Access Compliance Report

Public Rights-of-Way

(Curb Ramps)

Intersection ID: 12336	Main Street: CAMP_GREENE_ST	Cross Street: GREENLAND_AV	Location: NW
ADA ID: D05027D227E7	Ramp Type: PerpDiag	Initial Pass/Fail: Fail	Overall Compliance: No
Severity Score: 21.25			
Codes/Mitigation Info/Possible Solution		Field Measurements/Component Compliance

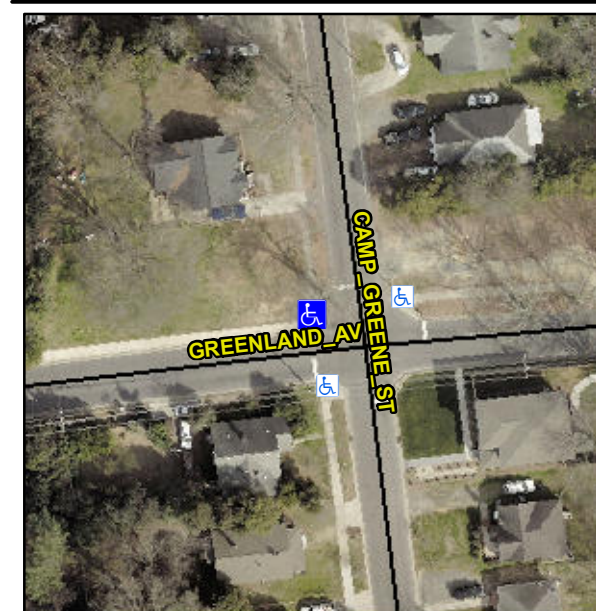
Not Found, R304.5.1, R304.2.2

Compliance	Description	Data	Compliance	Description	Data
N/A	Ramp Length (in)	60.0	No	Ramp Slope (%)	9.7
No	Ramp Width (in)	47.0	Yes	Ramp XSlope (%)	0.5
N/A	Flare Type LT	N/A	N/A	Flare Type RT	N/A
N/A	Flare Slope LT (%)	N/A	N/A	Flare Slope RT (%)	N/A
N/A	Flare Traversable LT?	N/A	N/A	Flare Traversable RT?	N/A
N/A	Landing Length (in)	N/A	N/A	DWS Provided?	N/A
N/A	Landing Width (in)	N/A	N/A	DWS Contrast?	N/A
N/A	Landing Slope (%)	N/A	N/A	DWS Length (in)	N/A
N/A	Landing X Slope (%)	N/A	N/A	DWS Full Width?	N/A
N/A	Landing Curb? (Y/N)	N/A	N/A	DWS Offset (in)	N/A
N/A	Shared Landing?	N/A			
N/A	Gutter Ponding?	N/A	N/A	Gutter Slope (%)	N/A
N/A	Gutter Lip Ht (in)	N/A	N/A	Gutter X Slope (%)	N/A
N/A	Painted X Walk1?	No	N/A	Painted X Walk2?	No
	X Walk 1 Direction	To S		X Walk 2 Direction	To E
N/A	X Walk 1 Width (in)	N/A	N/A	X Walk 2 Width (in)	N/A
	X Walk 1 Slope (%)	2.3		X Walk 2 Slope (%)	1.8
	X Walk 1 X Slope (%)	2.8		X Walk 2 X Slope (%)	0.8

Remove & Replace Curb Ramp With Two New Directional Ramps or Equivalent.
